MEMO

Date: June 28, 2022
To: Public Input Session Participants
From: Trey Akers, Project Manager
Re: Davidson Condos Conditional Map Amendment – Public Hearing Staff Analysis

**DAVIDSON CONDOS
CONDITIONAL MAP
AMENDMENT**

**PRELIMINARY
SKETCH PLAN**

MP-04

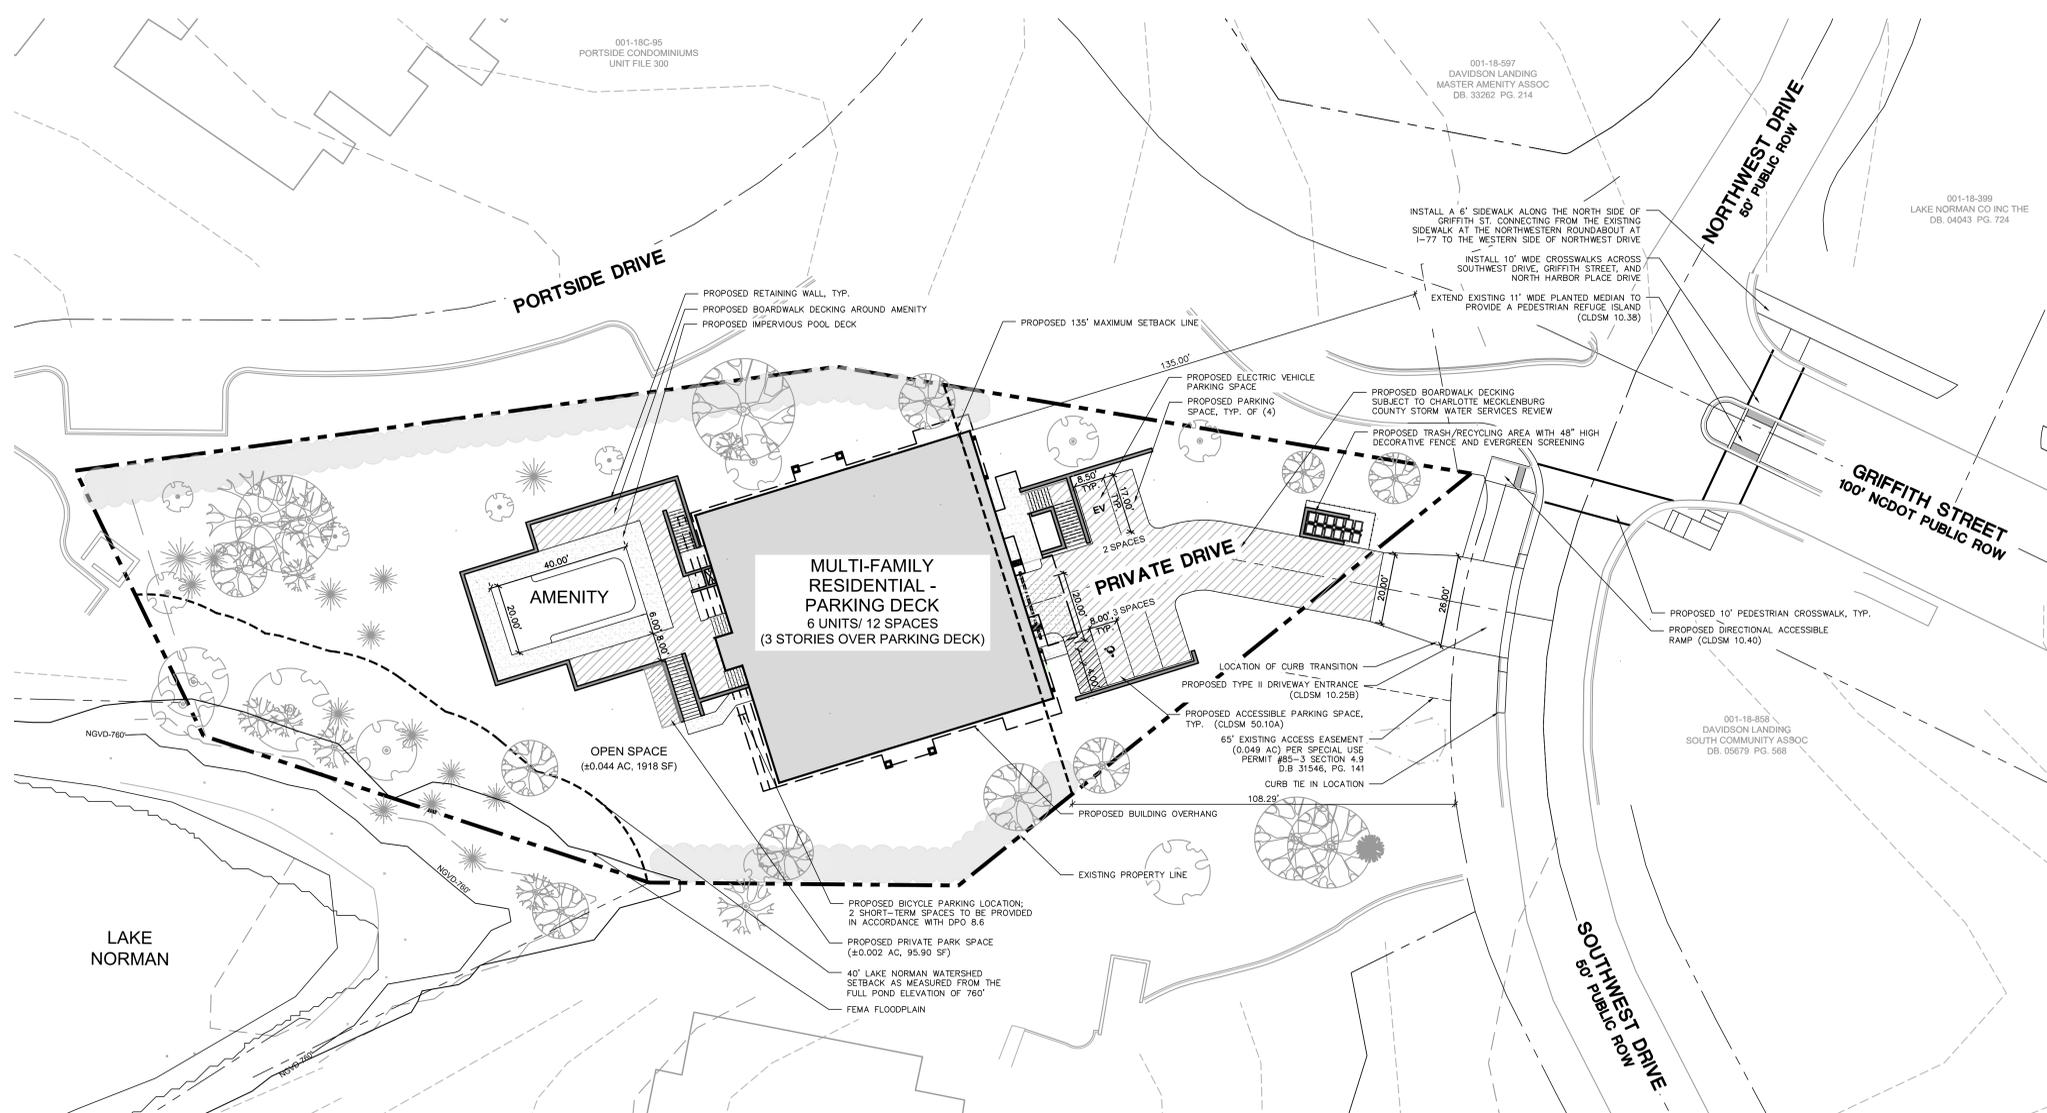
Regarding site access, the project originally included an internal sidewalk. As discussed in the Natural Assets section below, this feature's removal creates an opportunity for greater preservation/screening at the northeast corner. However, removing the sidewalk also makes it unclear whether pedestrians have safe access to the site – in particular because the sidewalk served as an ADA-compliant ramp connecting parking spaces to the building. Notably, existing buildings in the area provide sidewalk access from the parking areas to the buildings. Therefore, staff proposes that the project explore the inclusion of a two-way pedestrian area on the north/northwest side of the parking area drive aisle as a means of solving each of these issues (pedestrian safety, ADA-access). This could be indicated via [pavement markings](#) and/or [pedestrian symbols/sharrows](#).

- **Decking:** First, the current plans propose “boardwalk decking” to serve as the entire drive aisle and exterior parking area surfaces. This is not a permitted parking lot material (DPO 8.4.1.M) and presents long-term maintenance challenges for the future residents and possibly adjacent property owners at Windjammer Condominiums – on whose property part of the drive aisle lies. Nor is it clear that the proposed boardwalk decking meets fire code requirements for fire apparatus.

- **Width:** Second, the proposed 26’ drive aisle entry width exceeds the permitted 24’ width for parking areas (DPO 8.7.3). The Fire Dept. indicated a 24’ width was sufficient in this case.

- **Amount:** Third, the amount (17 spaces) exceeds the maximum listed in Table 8-1 (DPO 8.3.1). The ordinance permits a maximum of two spaces per unit. The project proposes 12 spaces underneath the building (two per unit) along with five visitor spaces lining the private drive (including one ADA-accessible space). Typically, on-street parking accommodates visitors but, in this case, no on-street parking is available on surrounding streets – the area features only off-street surface parking lots. On-site visitor park makes sense in this scenario and is consistent with area properties.

The Lakeshore Planning Area also requires a minimum of ten percent of existing tree canopy area to be preserved and a cumulative tree canopy post-project of 15 percent. The calculations demonstrate compliance thus far, though a few clarifications are needed. Additionally, an opportunity exists to preserve two additional specimen trees (Tree #56, 29" DBH, and #81, 31" DBH) by relocating the waste container storage area; this would increase the amount of specimen trees preserved to over 50 percent. The Town Arborist noted there's an opportunity for increased preservation at the site's northeast corner and with the removal of the internal sidewalk as now shown this prospect increases, though the current siting of the waste storage area works against this aim. Staff recommends relocating the waste storage area to the south side of the parking drive aisle in order to save these trees and maintain greater natural screening for the site.
